Beaver Valley Power Station, Unit No. 2  
Proposed Technical Specification Change No. 75

### Beaver Valley Power Station, Unit No. 2 Proposed Technical Specification Change No. 75 REVISION OF TABLE 4.3-1'S TABLE NOTATION (10)

**FIGURE 1**

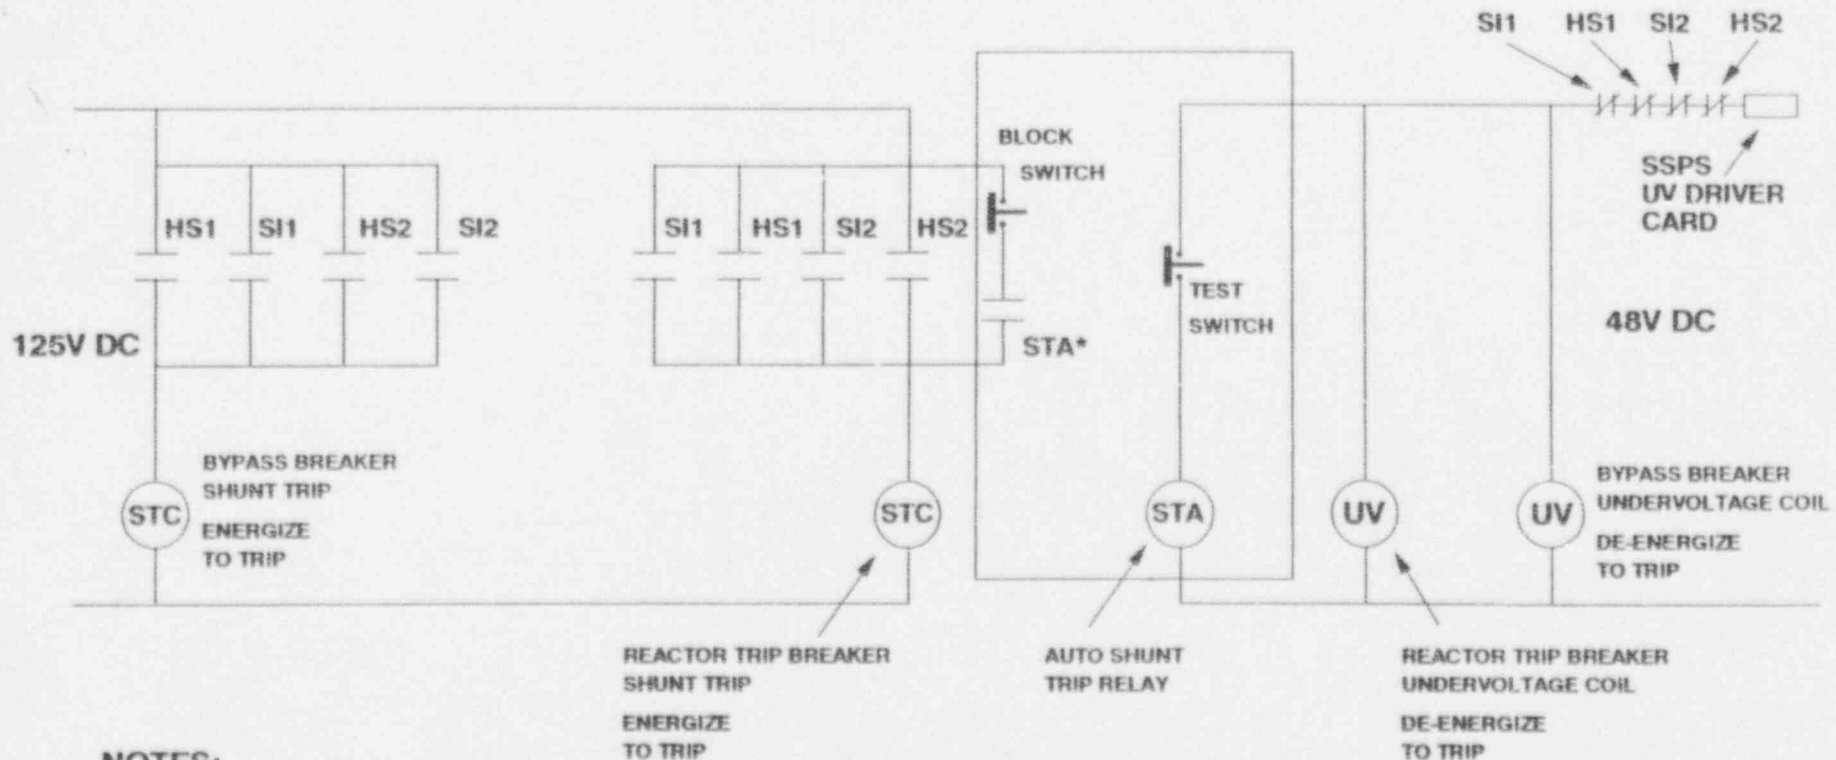
The ability of the Solid State Protection System (SSPS) to initiate a reactor trip via the undervoltage coil and indirectly energize the shunt trip coil has been verified. Should a reactor trip be required, this is the portion of the reactor trip system which would likely function to open the reactor trip breakers. It is unlikely that a manual reactor trip would be required. In the unlikely event that the operator was required to initiate a manual reactor trip and the signal did not reach the shunt trip coil, de-energization of the undervoltage coil would cause the reactor trip breakers to open. Additionally, when the undervoltage coil de-energizes, the auto shunt trip relay (STA) also de-energizes. This action closes a contact which will energize the shunt trip coil and open the reactor trip breakers. (Refer to Figure 1, Attachment D.)

The surveillance testing performed on the reactor trip breakers and the reactor trip bypass breakers was inadequate in that the capability of the manual reactor trip switches, located on the main control board, to directly actuate the shunt trip coil was not positively verified. However, the procedure does verify the capability of the manual reactor trip switches to trip the reactor via actuation of the undervoltage relay. The procedure verifies the operation of the shunt trip coil, however, it does not differentiate actuation from the benchboard switch contacts versus the undervoltage interfacing relay. (See Figure 1 attached.)
